**Resolution Copper Project and Land Exchange  
Environmental Impact Statement**

## **Process Memorandum to File**

### **Evaluation and Response to Public Comments on Groundwater Modeling Analysis**

Figure 1. Proposed Groundwater Modeling Process (Wels, 2012)

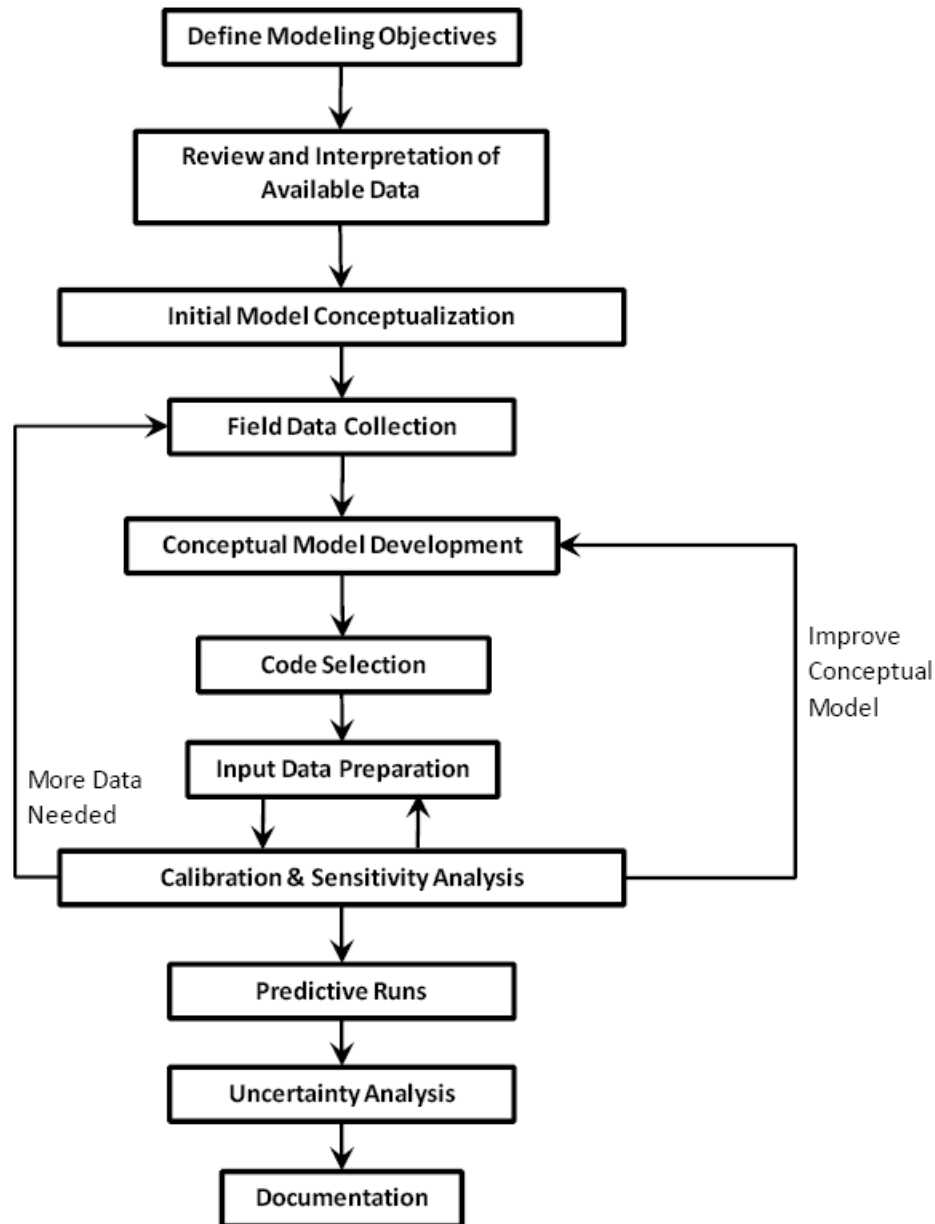
- Once models were created, the important feedback loops shown on Figure 1 from model calibration to conceptualization and data collection doesn't appear to have been considered. In other words, obvious datagaps identified during modeling weren't addressed.

- A formal predictive uncertainty analysis wasn't conducted, and partly confused with a predictive sensitivity analysis.

13	Once models were created, the important feedback loops shown on Figure 1 from model calibration to conceptualization and data collection doesn't appear to have been considered. In other words, obvious datagaps identified during modeling weren't addressed.			Practicality of collecting more data has to be considered.

Figure 2. Hydrologic Characterization and Conceptualization Approach, Kolm and Van der Heijde, 1996.

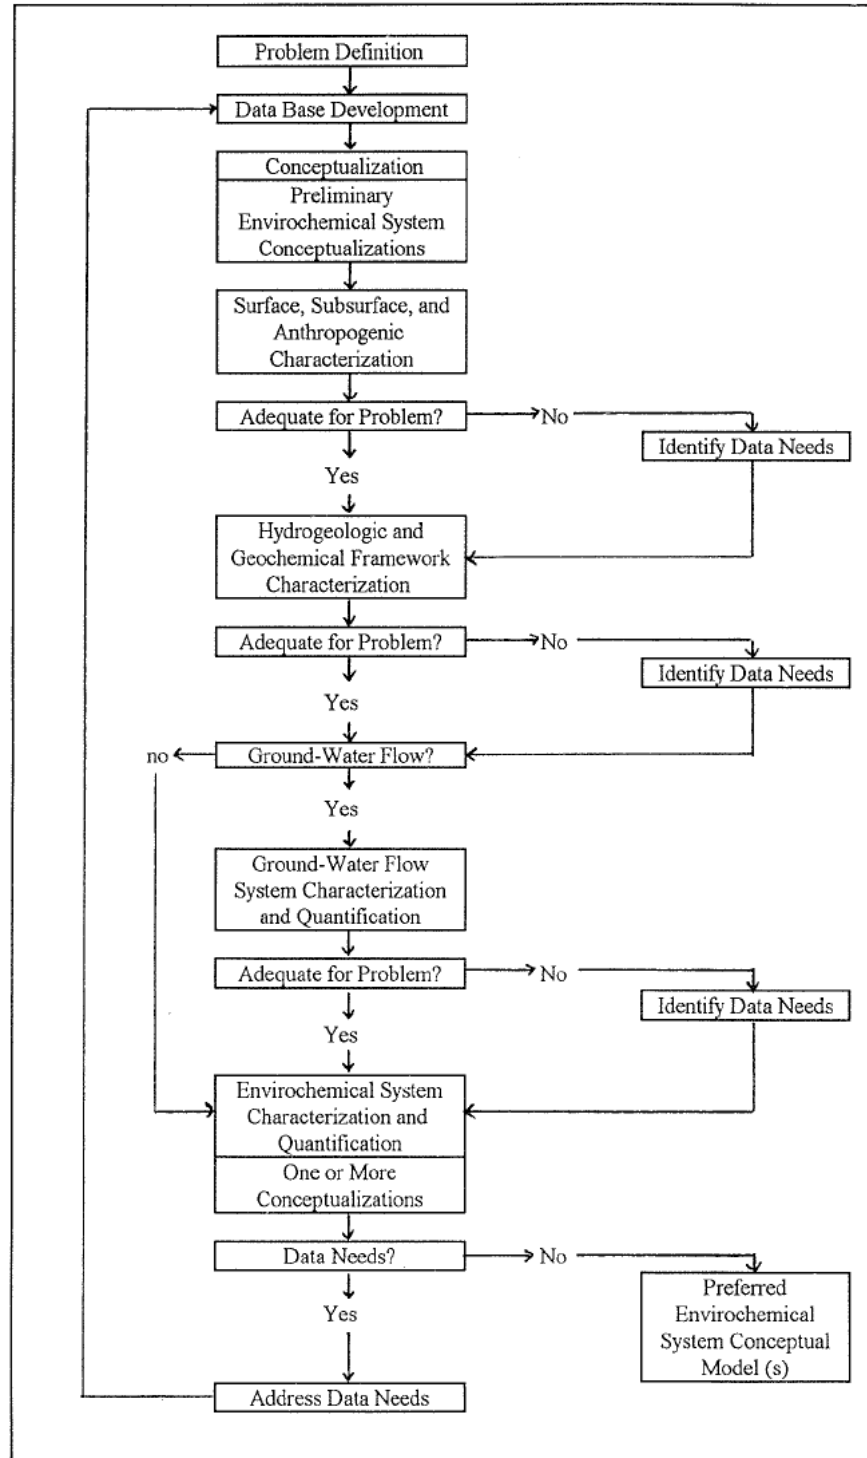
- d) The well-established industry practice (as defined in the flow chart on Figure 2 by Kolm and Van der Heijde, 1996) of going from raw data (i.e., borehole/well data) to characterization, for example of interpolated groundwater surface elevations for perched, shallow and deep aquifer units, over the mine-impacted area (including all TSF alternatives, West Plant, Superior, Queens Creek, MARRCO corridor etc), to conceptualization of flows (both vertical and lateral) within aquifer units, along faults,

No.	Comment	Response Source	Response from prior EIS document	Water Work Group Additional Thoughts
19	The well-established industry practice (as defined in the flow chart on Figure 2 by Kolm and Van der Heijde, 1996) of going from raw data (i.e., borehole/well data) to characterization, for example of interpolated groundwater surface elevations for perched, shallow and deep aquifer units, over the mine-impacted area (including all TSF alternatives, West Plant, Superior, Queens Creek, MARRCO corridor etc), to conceptualization of flows (both vertical and lateral) within aquifer units, along faults, discharge to surface, flows between surface water-groundwater, recharge from precipitation and runoff etc, is largely absent.	BGC 2018, Section 3.3.3	The conceptual model is based on site exploration and multiple reports. BGC and the GWMG concur that the hydrostratigraphic and hydrostructural units have been appropriately conceptualized using available site specific geologic and hydrogeologic test boreholes, hydrologic testing, historic mining data, and current underground exploration mine and shaft data. Note that evaluation of the geologic and hydrogeologic conceptual model extends well beyond just the groundwater model. Substantial review of the available geologic and geotechnical information has been conducted by a Geology and Subsidence Workgroup (Geology Workgroup), which was formed by the Resolution Copper Project EIS team in order to review RCM's procedures, data, and geologic and geotechnical baseline documents and subsidence model.

Figure 3. Modified conceptual West-East section through future fractured crater. Note it shows no adjustment to landsurface. Recovered water levels and revised groundsurface added.

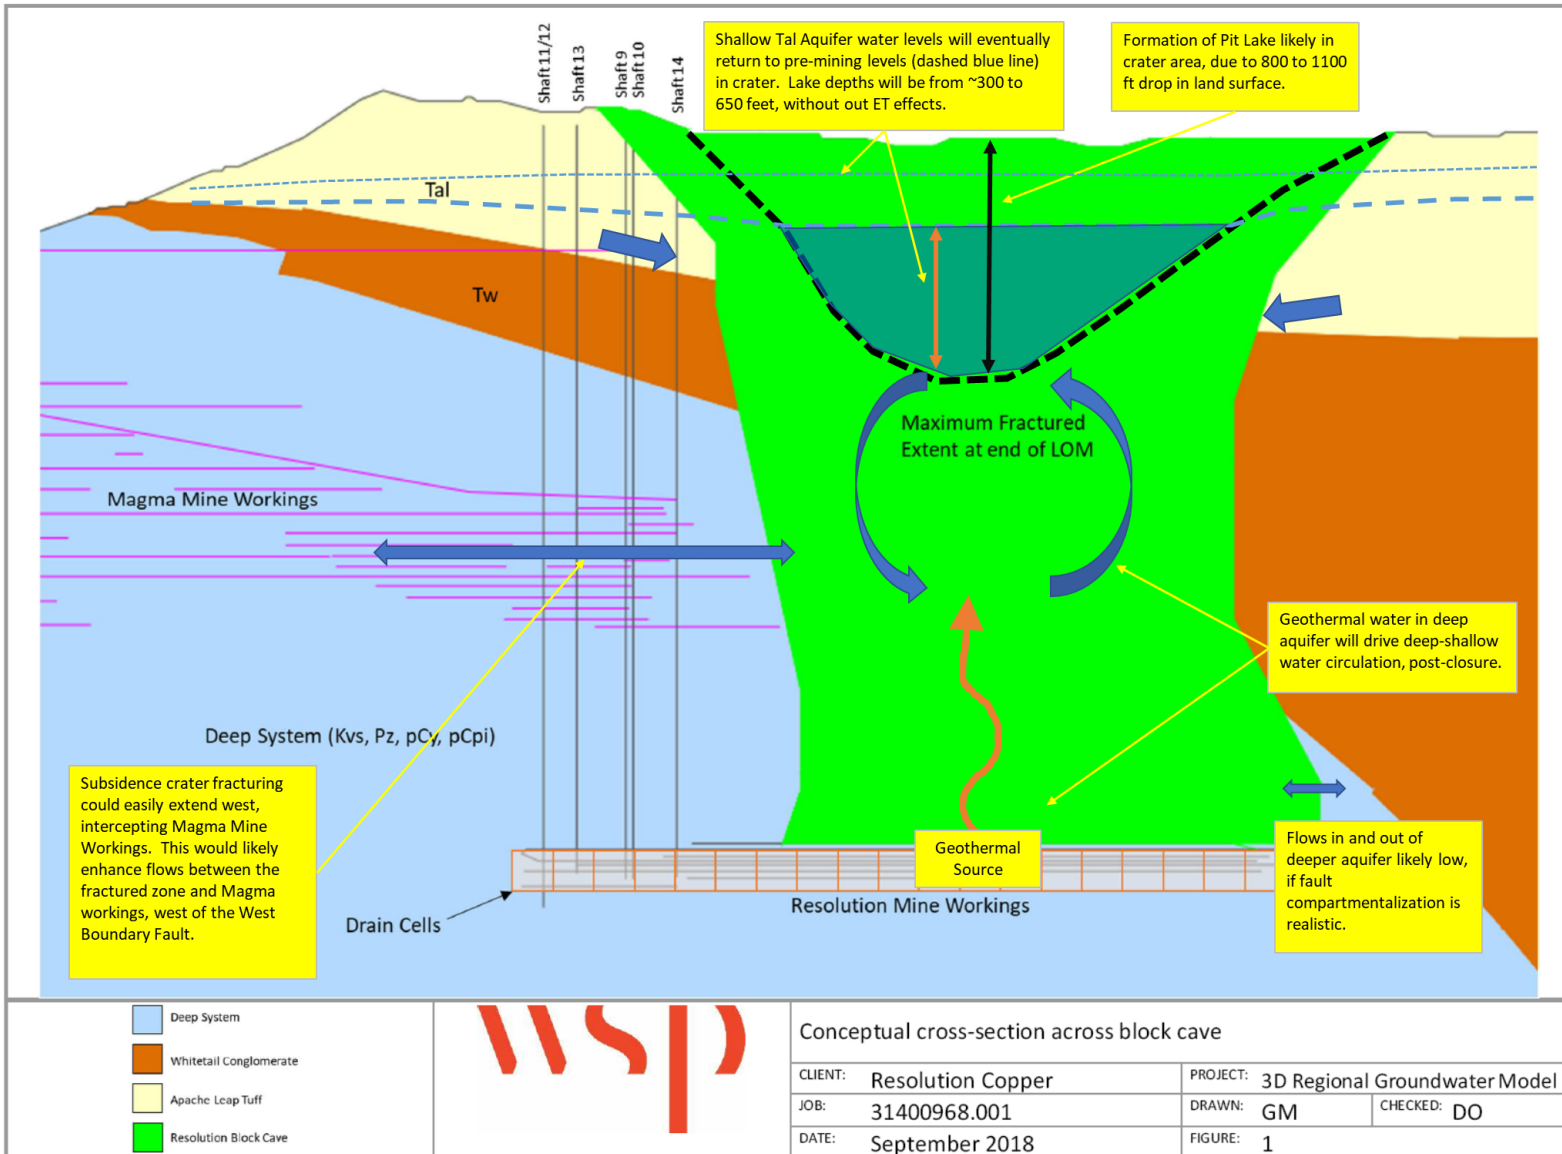
- WSP, 2019 failed to include the change in the ground surface due to the crater in the future condition groundwater modeling. Conservatively, they should have dropped the surface 1100 ft, and let the groundwater model simulate eventual development of the subsidence crater, which would, like the Rosemont mine DEIS modeling that also showed long-term development of a pitlake, change the long-term, or eventual groundwater flow regime. More importantly, with continued evaporation, the pitlake waters would likely also significantly change predicted long-term water quality predictions and risks in the area of this pitlake.

- Figure 1 from Meza-Cuadra, 2018b<sup>31</sup> was revised to reflect conceptually what the WSP, 2019 groundwater model should have simulated (change in land surface), and the eventual development of a pitlake as groundwater levels recover. WSP should have included this type of Future Processes Conceptual Model, which is industry standard (see Potential Errors in Conceptual Modeling, Section 4.6 in [Wels, 2012](#)<sup>1</sup>). Rosemont DEIS groundwater modeling of the development of a pitlake was developed using Modflow-Surfact coupled to a dynamic systems model using the GoldSim code<sup>32</sup>.

- 2 IHS expresses the need to model the change in ground surface elevation associated with the subsidence crater for the purpose of conducting a subsidence lake assessment

This is an incorrect assumption. Once block-caving begins, the upper fractured zone where the subsidence crater will develop is unsaturated with respect to the regional aquifer. This is clearly shown in the DEIS, in Figure 3.7.2-4 (p. 377). There is no groundwater flow in this area and the modeling indicates there will not be groundwater flow in this area even 1,000 years in the future. There is indeed water percolating downwards from precipitation, but this downward movement is essentially decoupled recharge to the aquifer. The modeling of a change in elevation of land surface above the regional aquifer has no bearing on the outcome of the model.

Figure 4. Long-term Drawdown (greater than 1 foot) likely extends several kilometers out in all directions (Red zone shows 4 km buffer around 10 foot maximum drawdown area in DEIS. Blue areas are SW Quantity Analysis Areas (from Figure 3.7.3-1 in DEIS).

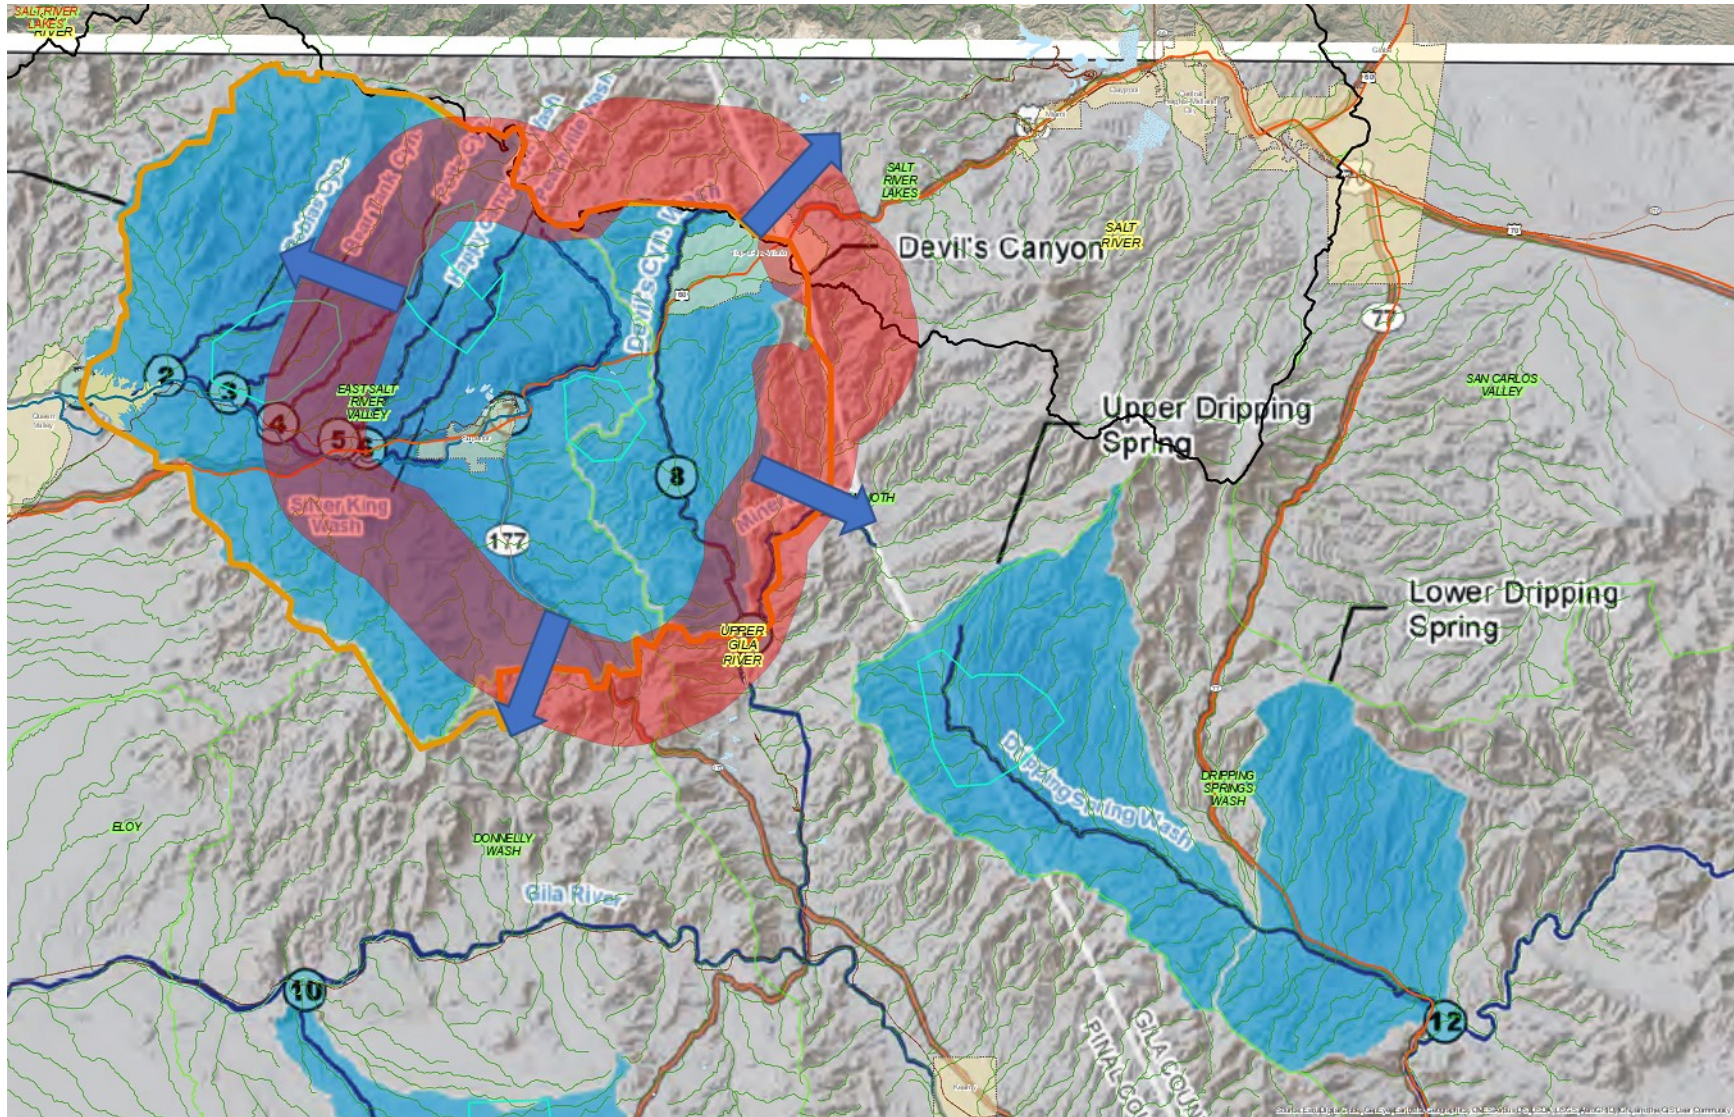
Figure 4 below shows a more likely long-term drawdown (at steady state, not arbitrary 148 years after closure) 4 km out from the arbitrarily chosen 10' drawdown, which should really have shown predicted drawdowns of <1', or something which would impact groundwater discharge areas (springs, baseflow in streams, riparian vegetation etc). The figure shows that additional SW areas would likely be affected by long-term drawdown, than evaluated in the DEIS. The DEIS should have also assess impacts within the following watersheds:

- a.** North of Queen Creek, including Haunted Canyon, Upper Pinto Creek, and West Fork watersheds.
- b.** Walnut Canyon to the south, which drains into the Gila River via Donnelly Wash.

No.	Comment	Response Source	Response from prior EIS document	Water Work Group Additional Thoughts
68	<p>Figure 4 below shows a more likely long-term drawdown (at steady state, not arbitrary 148 years after closure) 4 km out from the arbitrarily chosen 10' drawdown, which should really have shown predicted drawdowns of &lt;1', or something which would impact groundwater discharge areas (springs, baseflow in streams, riparian vegetation etc). The figure shows that additional SW areas would likely be affected by long-term drawdown, than evaluated in the DEIS. The DEIS should have also assess impacts within the following watersheds:</p> <p>a. North of Queen Creek, including Haunted Canyon, Upper Pinto Creek, and West Fork watersheds.</p> <p>b. Walnut Canyon to the south, which drains into the Gila River via Donnelly Wash.</p>	BGC 2018, Section 5.7	Tonto National Forest asserts that: ...Operational monitoring of all potentially impacted groundwater-dependent ecosystems, regardless of groundwater model predictions of impact, provides a backstop to the acknowledged uncertainty of the groundwater model.	Steady state will be a long time out, and the atmospheric inputs and outputs to the system may have changed appreciably over this time

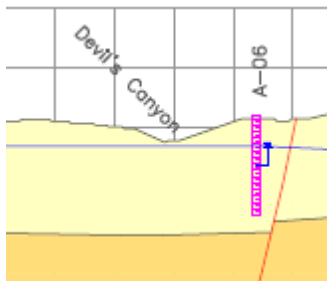
“...Inferred Tal Water Table at Devil’s Canyon at the bottom of the streambed...” This is an incorrect statement, as shown below; the inferred Apache Leap Tuff water table does not intersect the bottom of the streambed in WSP 2019, Figure 2.3.

- BGC notes that the GDE conclusions are based on best available site information, and show enough evidence to conclude that Upper Devils Canyon baseflow is unlikely to be connected to TAL.
- BGC suggests looking to see if conclusions could be strengthened with analysis proposed in comment

- Garrett 2018d, see specifically table 2, p. 23-24 for specific lines of evidence leading to conclusions that Upper Devil's Canyon locations (including DC 13.5) are disconnected from Apache Leap Tuff aquifer. As an example (DC 13.5):
